REF: SUP25-0023  
DATE: August 14, 2025

Request - Amendment to Special Use Permit, Originally Granted by Ord.143-24, for Polish Cultural Center

Location - 1600 Mott Avenue (parcel #1627991)

# LANDSCAPE PLAN

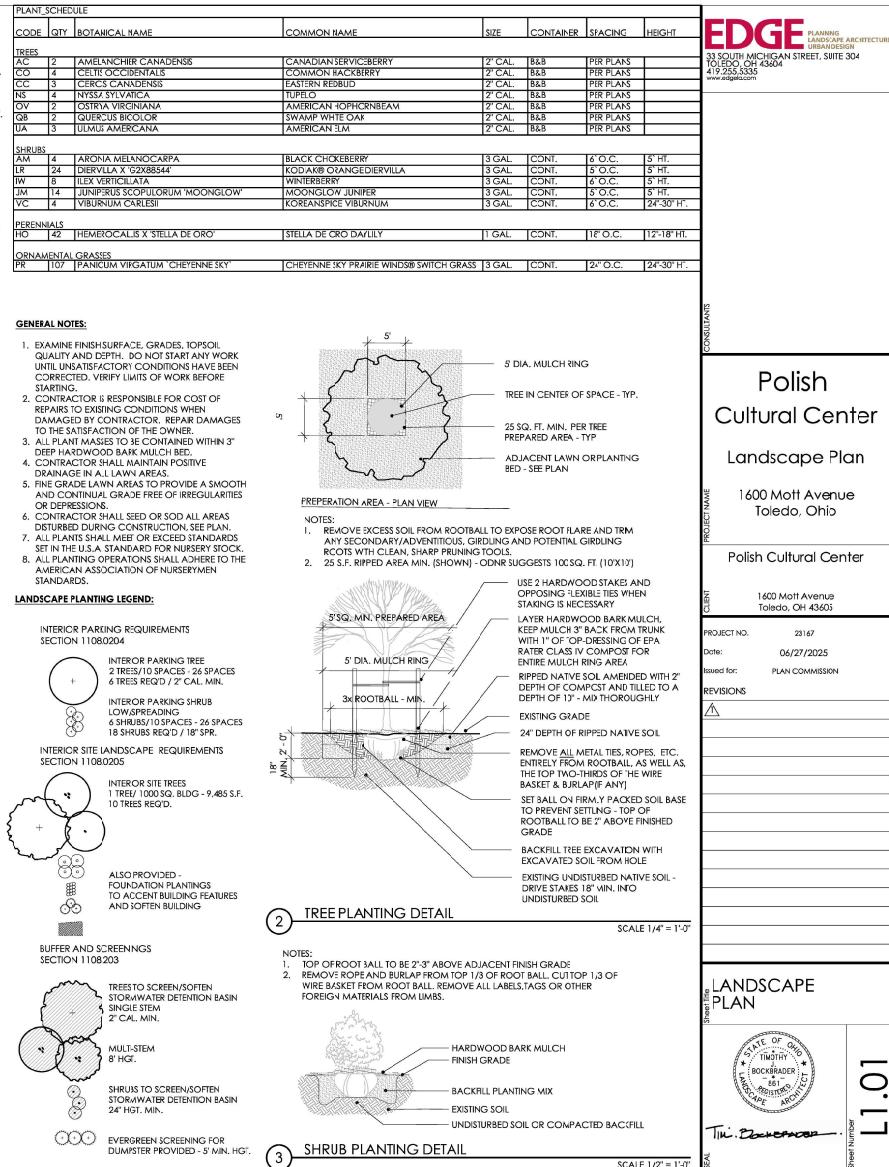
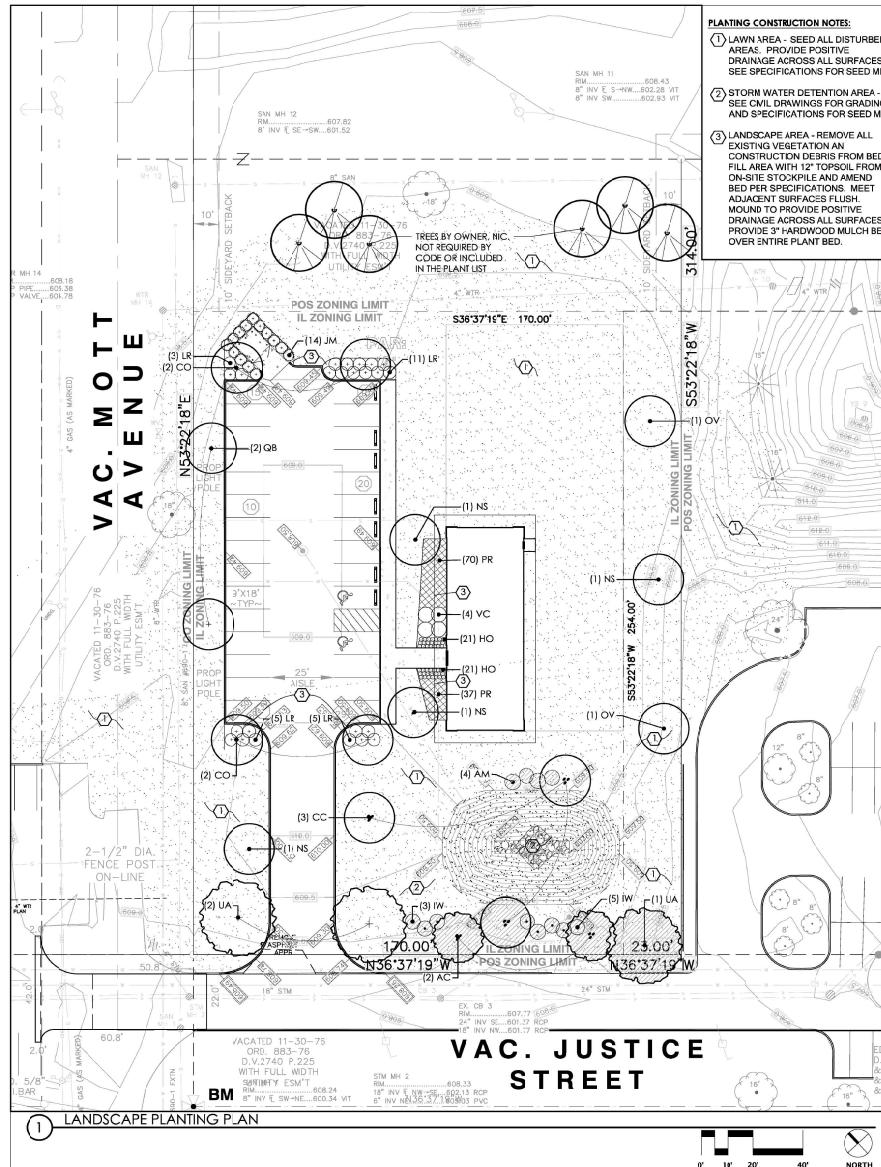
Furthermore, the POS zoning distinction does not trigger any screening requirements between abutting properties as per TMC§1108.0203 – *Buffer and Screening Requirements*. However, the site plan depicts a greenbelt along the southwestern edge of the parcel to screen the proposed stormwater detention basin. This greenbelt is comprised of five (5) trees and a continuous shrub row and is acceptable as depicted. Screening comprised of five-foot (5') evergreens is also depicted surrounding three (3) sides of the proposed dumpster. These plantings will be accompanied by a fence or wall structure surrounding all four (4) sides of the dumpster, as required by TMC§1108.0203(G), and shall be shown on a revised plan.

Interior parking lot plantings, as specified in TMC§1108.0204, must provide two (2) canopy trees and six (6) shrubs for each ten (10) parking spaces. With twenty-six (26) proposed spaces, the required interior planting area must be comprised of at least six (6) trees and sixteen (16) shrubs. The current site plan depicts six (6) trees and twenty-four (24) shrubs and is acceptable as depicted. In addition, perimeter parking lot plantings are required to visually screen parking facilities from view of Residential districts and public right-of-ways. A minimum of at least one (1) canopy tree must be provided for each thirty (30) linear feet, plus a continuous shrub with a minimum height of eighteen (18) inches. Plans depict adequate perimeter parking plantings to screen the parking lot from the Residential district to the southwest.

Finally, interior site landscaping requirements specify that the site plan must provide one (1) two-inch (2") caliper tree for every 1,000 square feet of building coverage. Three (3) trees are required at minimum. The landscaping plan meets the requirements for interior landscaping with the provision of fourteen (14) trees, in addition to the required parking lot landscaping. The plan also depicts foundation plantings to frame the entranceway to the building.

- a. Dumpster location(s) shall be clearly defined, have a concrete pad and be screened on all four sides by any combination of evergreen plantings, fence, or wall structure and shall not be located in any required setbacks or the public right-of-way as stated in TMC§1361.10(b)(10) of the Building Code. **Not acceptable as depicted. The plantings depicted on the site plan will be accompanied by a fence or wall structure surrounding all four (4) sides of the dumpster, as required by TMC§1108.0203(G) and shall be depicted on a revised site plan.**

- b. Perimeter landscaping shall be installed along any parking lot area adjacent to a street, place, or driveway and shall be provided abutting the parking area to visually screen all off-street loading facilities from view of public rights-of-way. A minimum of at least one canopy tree must be provided for each thirty (30) linear feet, plus a continuous shrub with a minimum height of eighteen inches (18"); **Acceptable as depicted on site plan.**

- c. Interior landscaping required in parking lots is 20 square feet per parking space. Two (2) canopy trees are required to be installed in interior landscape areas for each ten (10) parking spaces within the parking lot. Six (6) shrubs are required to be installed in interior landscape areas of each ten (10) parking spaces within the parking lot; **Acceptable as depicted on site plan.**

- g. If the site is  $\frac{1}{2}$  acre or larger, landscaped areas must be irrigated as necessary to maintain required plant materials in good and healthy condition. Irrigation plans must be submitted with development plans and must contain all construction details; **Not acceptable as depicted; applicant shall provide irrigation plans for the site as it is larger than  $\frac{1}{2}$  acre.**

# ELEVATIONS

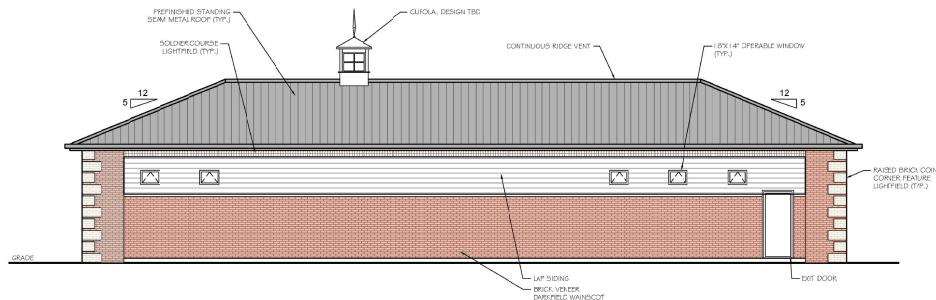
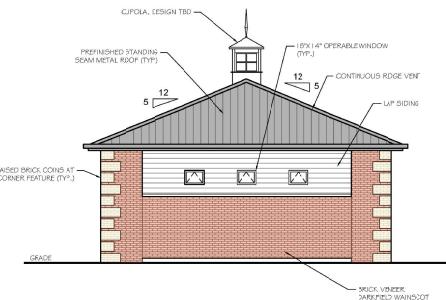
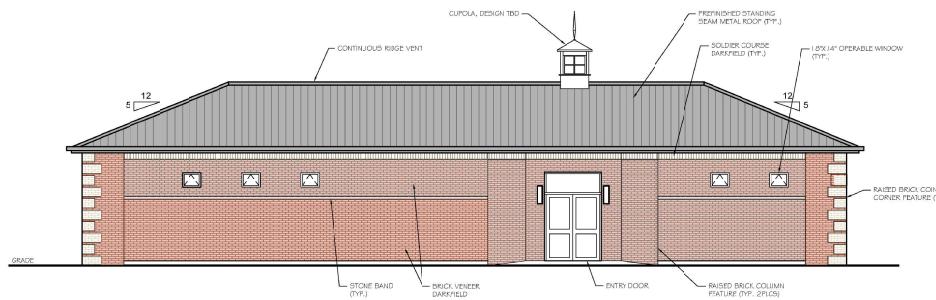
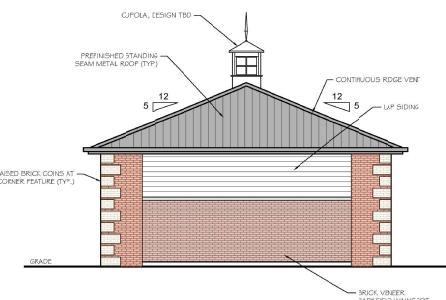
The proposed building elevations are comprised of brick veneer and wood-lap siding. The proposed brick is classified as “predominant materials” and the wood-lap siding is classified as an “accent material” per TMC§1109.0500 – *Building Façade Materials and Color*. In order to adhere to this code section, predominant materials must consist of at least 80% of each elevation and only up to 20% of each elevation may be comprised of accent materials. The south elevation meets these thresholds however, the remaining three (3) elevations do not meet the predominant material threshold and exceeds the accent materials permitted. Revised elevations must depict material types and percentages that are in conformance with TMC§1109.0500, and is listed as a condition of approval.

38. Building elevations shall be of quality materials as stated in TMC§1109.0500. **Not acceptable as depicted, as accent materials proposed surpass 20% of each elevation. Revised elevations must be submitted depicting material types and percentages that are in conformance with TMC§1109.0500.**
